Intel® Pentium® III Processor Specification Update

Release Date: April 2002

Order Number: 244453-040

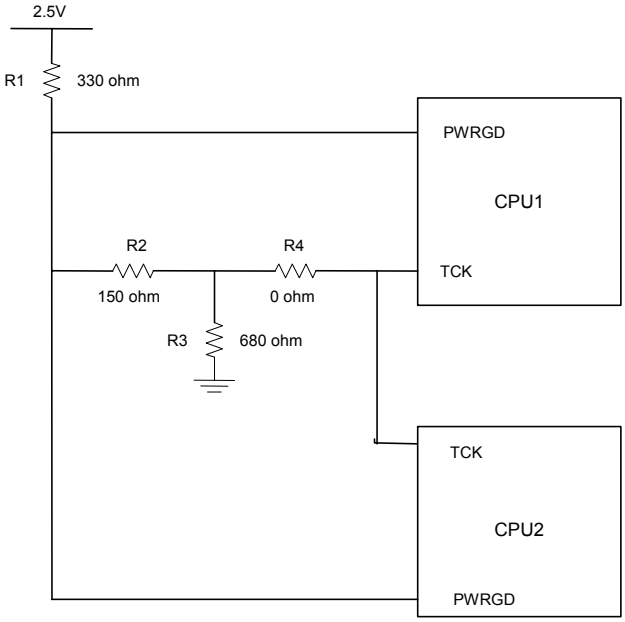
Problem: The internal control register bit responsible for operation of the Thermtrip circuit functionality may power up in a non-initialized state. As a result, THERMTRIP# may be incorrectly asserted during de-assertion of RESET# at nominal operating temperatures. When THERMTRIP# is asserted as a result of this erratum, the processor may shut down internally and stop execution but in few cases continue to execute.

Implication: This issue can lead to intermittent system power-on boot failures. The occurrence and repeatability of failures is system dependent, however all systems and processors are susceptible to failure. In addition, the processor may fail to stop execution during the event of a valid THERMTRIP# assertion resulting in the potential for permanent processor damage.

Workaround: To prevent the risk of power-on boot failures or catastrophic thermal failures, a platform workaround is required. The system must provide a rising edge on the TCK signal during the power-on sequence that meets all of the following requirements:

- Rising edge occurs after Vcc_core is valid and stable
- Rising edge occurs before or at the de-assertion of RESET#
- Rising edge occurs after all Vref input signals are at valid voltage levels
- TCK input meets the Vih min and max spec as mentioned in EMTS

Figure 1: Noise Estimation

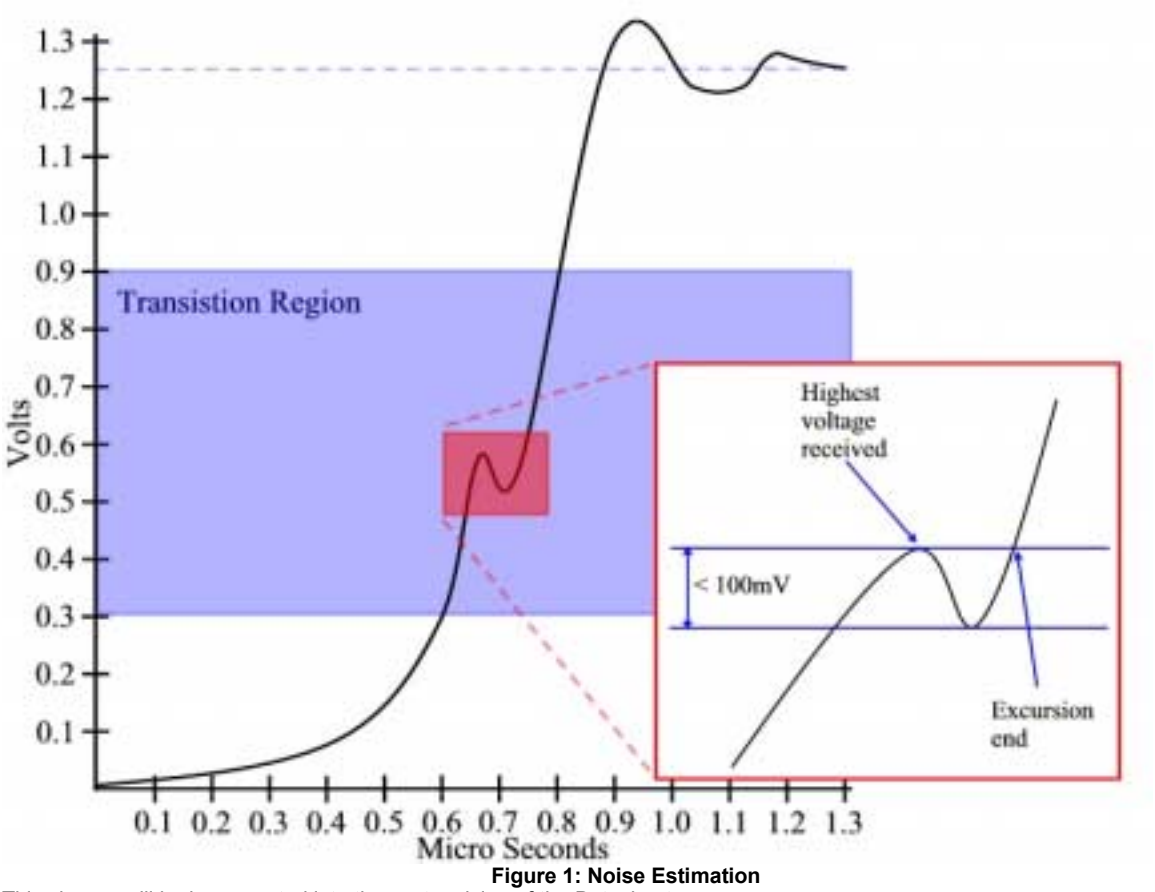
The signal quality of the VTT_PWRGD signal is critical to the correct operation of the processor. Every effort should be made to ensure this signal is monotonic in the transition region. If noise or glitches are present on this signal, it must be kept to less than 100mV of a voltage drop from the highest voltage level received to that point. This glitch must remain less than 100mV until the excursion ends by the voltage returning to the highest voltage previously received. Please see Figure 1 for an example graph of this situation and requirements.

This change will be incorporated into the next revision of the Datasheet.
